**CENTRAL ARKANSAS WATER
JACK H WILSON WATER TREATMENT PLANT
WILSON RENEWAL AND RESILIENCY PROJECT
ADDENDUM NO. 5
JANUARY 30, 2025**

This Addendum forms part of the Contract Documents and modifies the Specifications and Drawings as noted below. Acknowledge receipt of the Addendum in the space provided on the Bid Proposal. Failure to acknowledge receipt of the Addendum may subject the Bidder to disqualification.

DATE:	NOVEMBER 2024
HAZEN NO.:	60711-003
CONTRACT NO.:	1
DRAWING NUMBER:	S2205

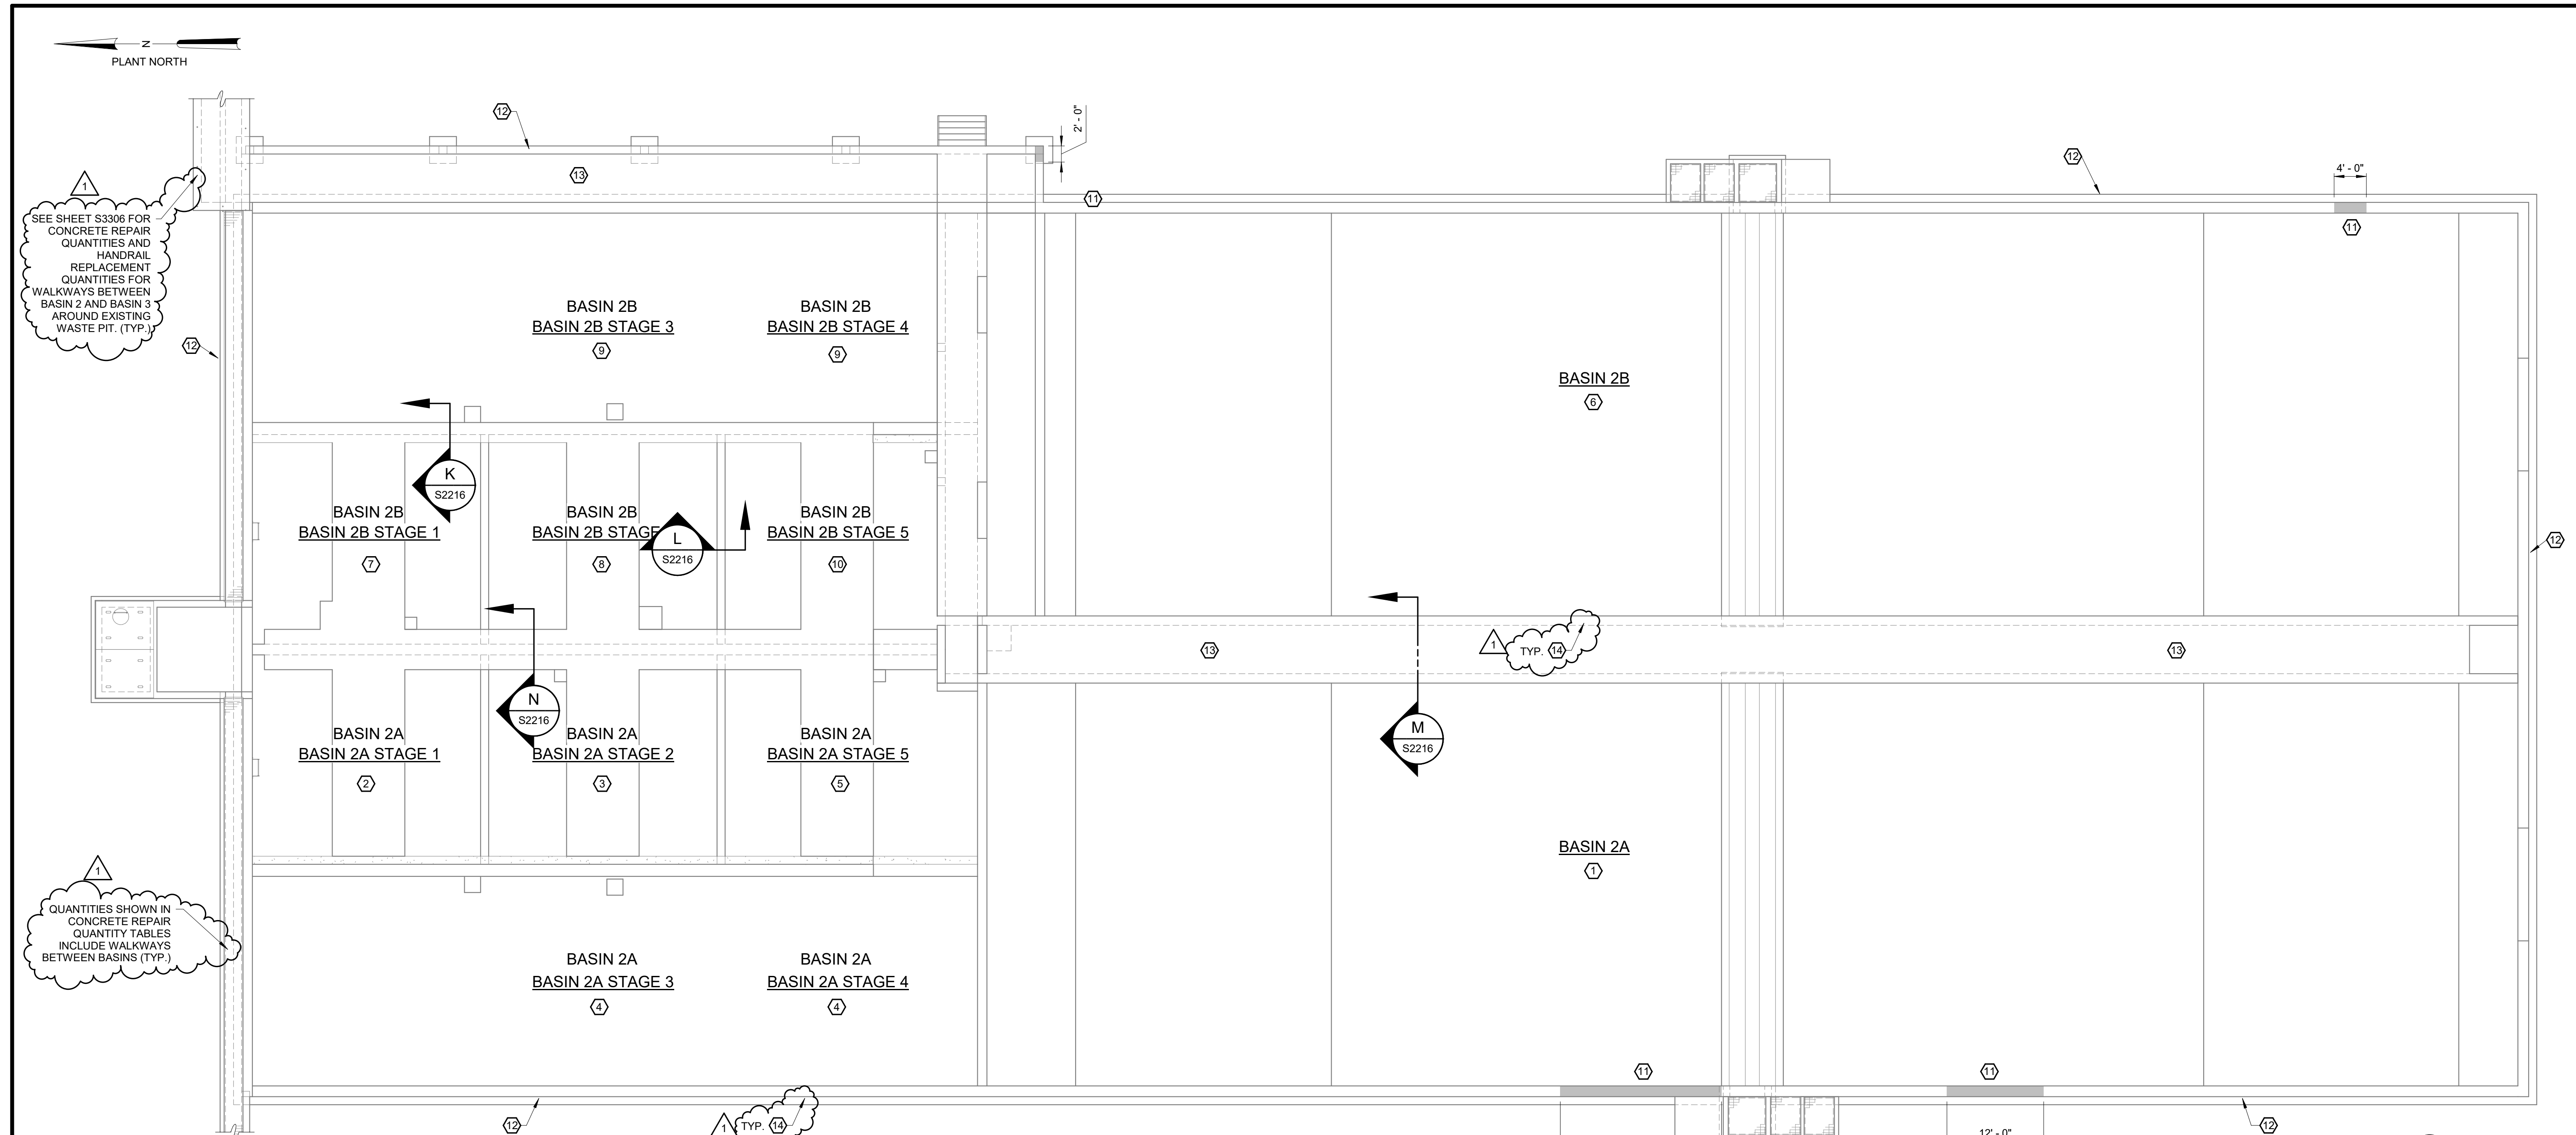
SEE SHEET S3306 FOR CONCRETE REPAIR QUANTITIES AND HANDRAIL REPLACEMENT QUANTITIES FOR WALKWAYS BETWEEN BASIN 2 AND BASIN 3 AROUND EXISTING WASTE PIT. (TYP.)

- HANDRAIL PENETRATION REPAIR QUANTITIES INCLUDE EXTERIOR BASIN HANDRAIL, BASIN INTERIOR WALKWAY HANDRAIL, AND WALKWAYS NORTH OF THE BASINS. HANDRAIL PENETRATIONS WHERE TOP OF WALL REPAIRS ARE SPECIFIED ARE NOT INCLUDED IN THE QUANTITIES. S-03-902 S-03-903
- THE TOP OF WALL REPAIR LOCATIONS ARE SHOWN FOR REFERENCE. THE REPAIR LIMITS WILL BE MARKED IN THE FIELD DURING CONSTRUCTION.
- THE SETTLED WATER CHANNELS WERE NOT ACCESSED DURING DESIGN. THEREFORE THE QUANTITIES ESTIMATED FOR CRACK REPAIR, PARTIAL DEPTH REPAIR, AND EXTENDING EXPANSION/CONTROL JOINT THROUGH PROPOSED COATING IS BASED ON AN ASSUMED QUANTITY. THE ASSUMED QUANTITY IS PROPORTIONAL TO THE CONCRETE REHABILITATION QUANTITIES IN THE FLOCCULATION/SEDIMENTATION BASIN IN WHICH THEY ARE LOCATED.
- ALL HANDRAILS FOR BASIN 2 SHALL BE ADA COMPLIANT.

DATE:	NOVEMBER 2024
HAZEN NO.:	60711-003
CONTRACT NO.:	1
DRAWING NUMBER:	S3306

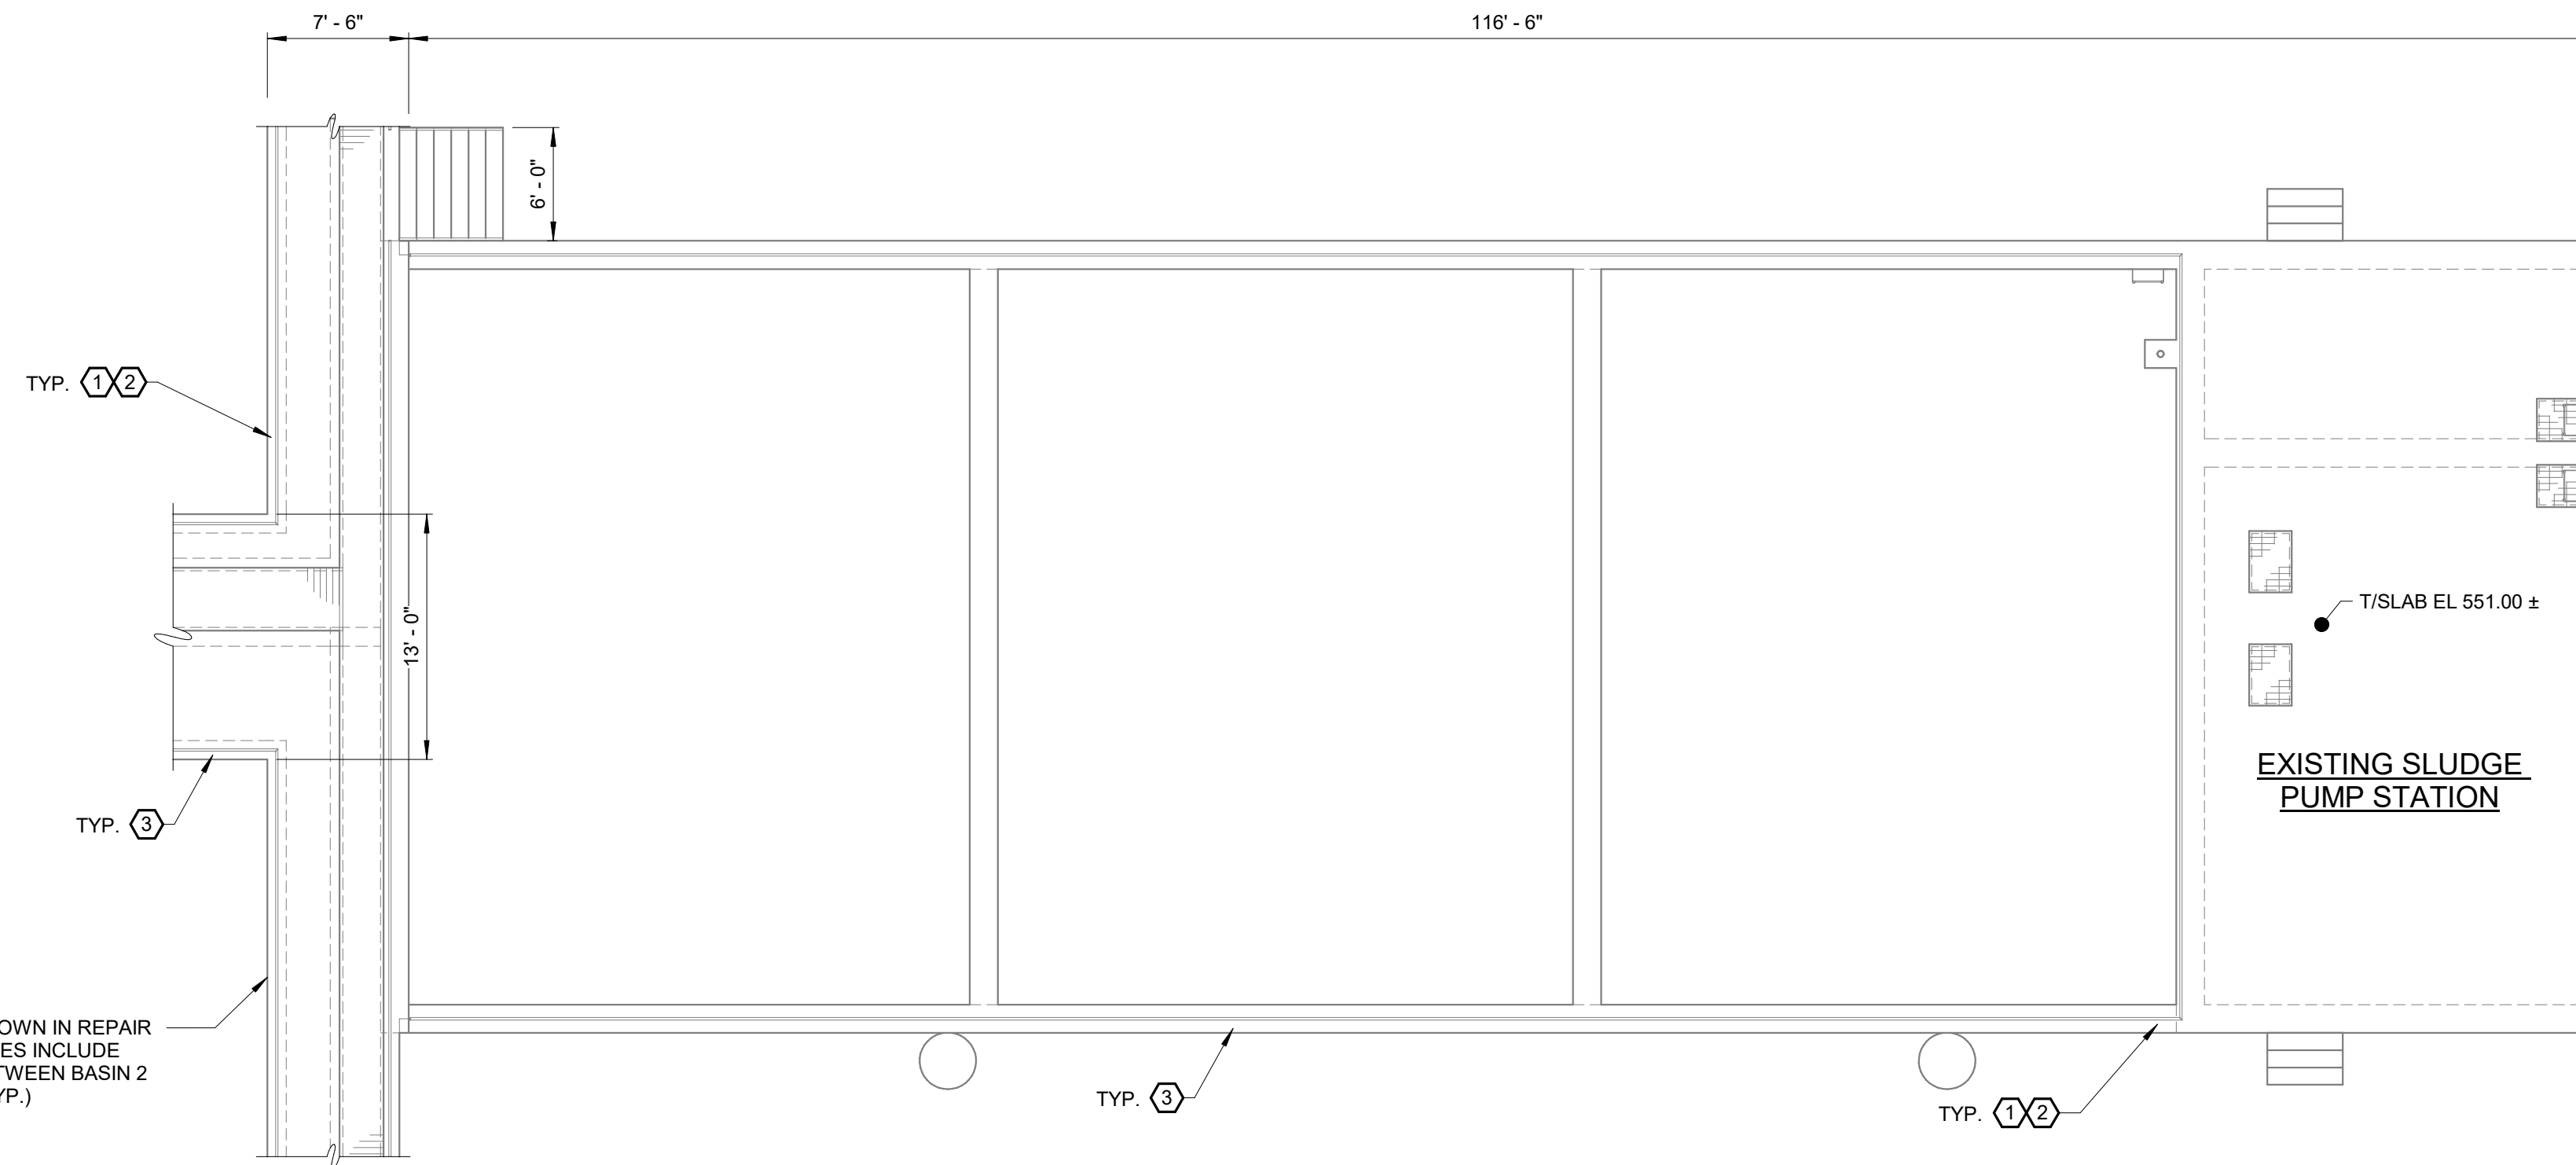
- a. Replace drawing S2306 FLOCCULATION AND SEDIMENTATION BASINS – STRUCTURAL – OVERALL PLAN – CONCRETE REPAIR – BASIN 3 in its entirety with the one attached to this addendum.
9. Drawing S2401 FLOCCULATION AND SEDIMENTATION BASINS – STRUCTURAL – OVERALL PLAN – CONCRETE REPAIR – BASIN 4
 - a. Replace drawing S2401 FLOCCULATION AND SEDIMENTATION BASINS – STRUCTURAL – OVERALL PLAN – CONCRETE REPAIR – BASIN 4 in its entirety with the one attached to this addendum.
10. Drawing S3306 WASTE PIT – STRUCTURAL – CONCRETE REPAIRS
 - a. Add the attached new drawing sheet S3306 WASTE PIT – STRUCTURAL – CONCRETE REPAIRS.
